Invitation to Bid 15131 – Addendum 2 Construction on behalf of Edna Bay Community, Bulk Fuel Upgrade

Addendum 2 is issued to answer the following questions:

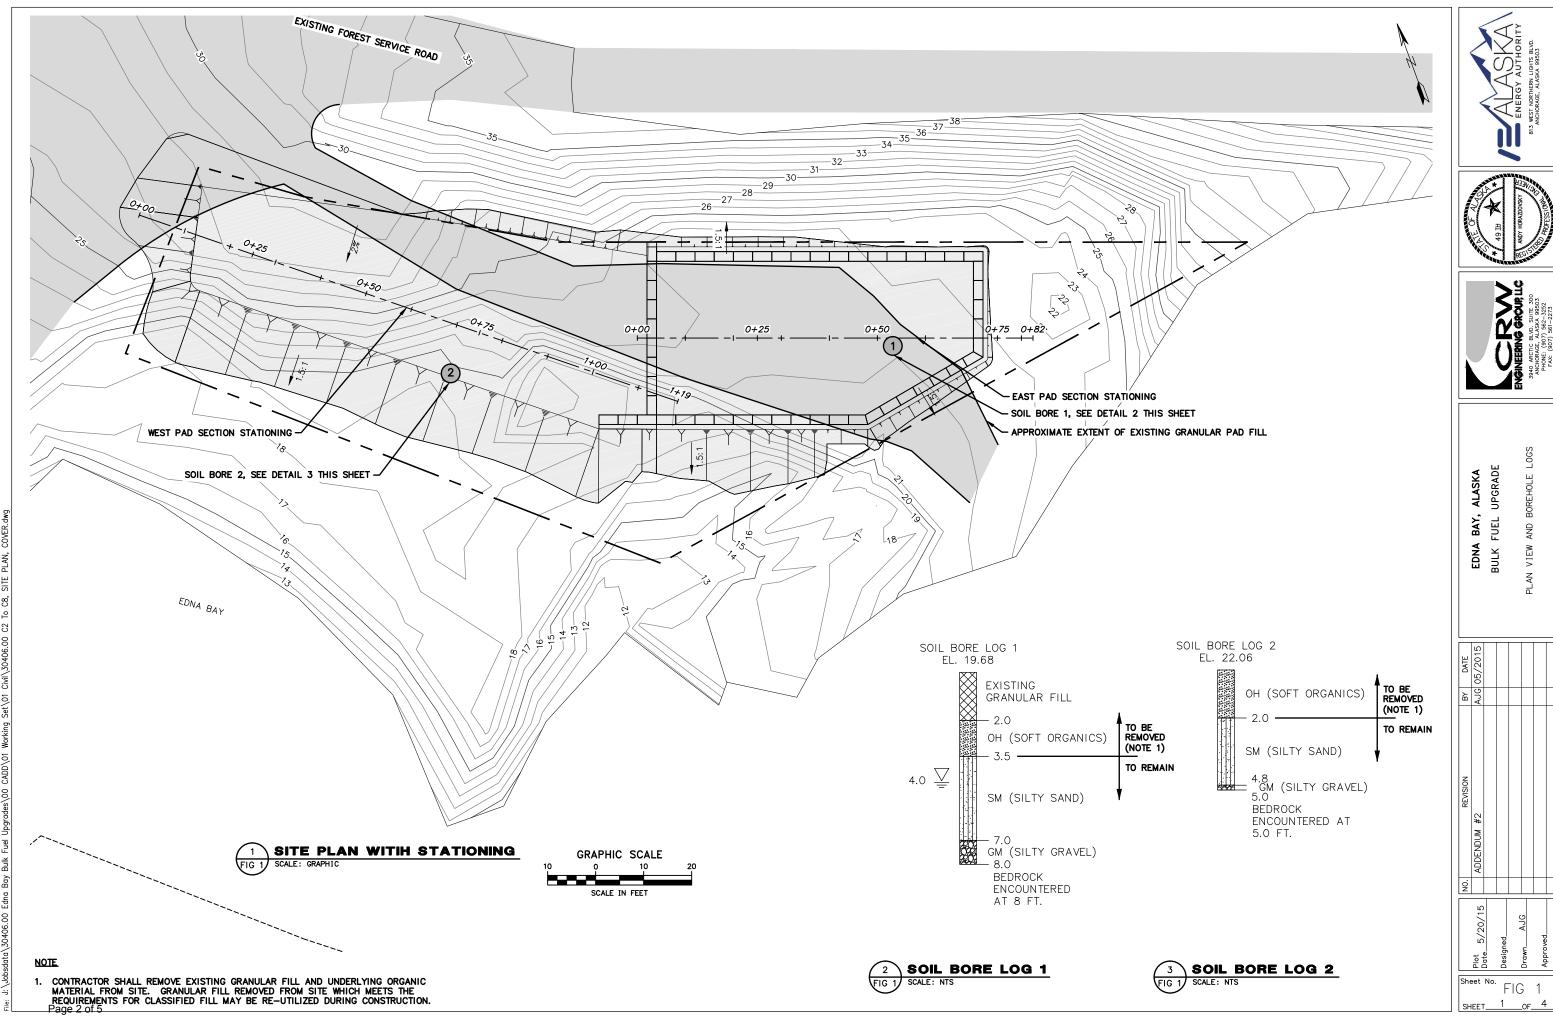
- a. Can the Engineer provide site cross sections on a 25' to 50' interval with no vertical exaggeration so we can perform our own average end area calculation for the grading quantities needed for the lump sum bid?
- b. Also, how did the engineer determine that there was only 2' of organic overburden that will have to be removed from the site? Was there a site probe done to verify the thickness of the organic overburden? Provide any data concerning the 2' organic overburden.

- a. The requested cross sections are shown on the attached figures.
- b. Two test holes were excavated at the proposed tank farm site. Test hole locations and soil logs are provided on Figure 1. A portion of the proposed tank farm site is covered by an existing granular fill pad. The approximate extents of the existing gravel pad are also shown on Figure 1. Where present, the granular fill pad appears to be 2-ft thick and rests directly on the surface organic soil layer. The surface organic soil layer varied from 1.5' to 2' thick in the areas tested.
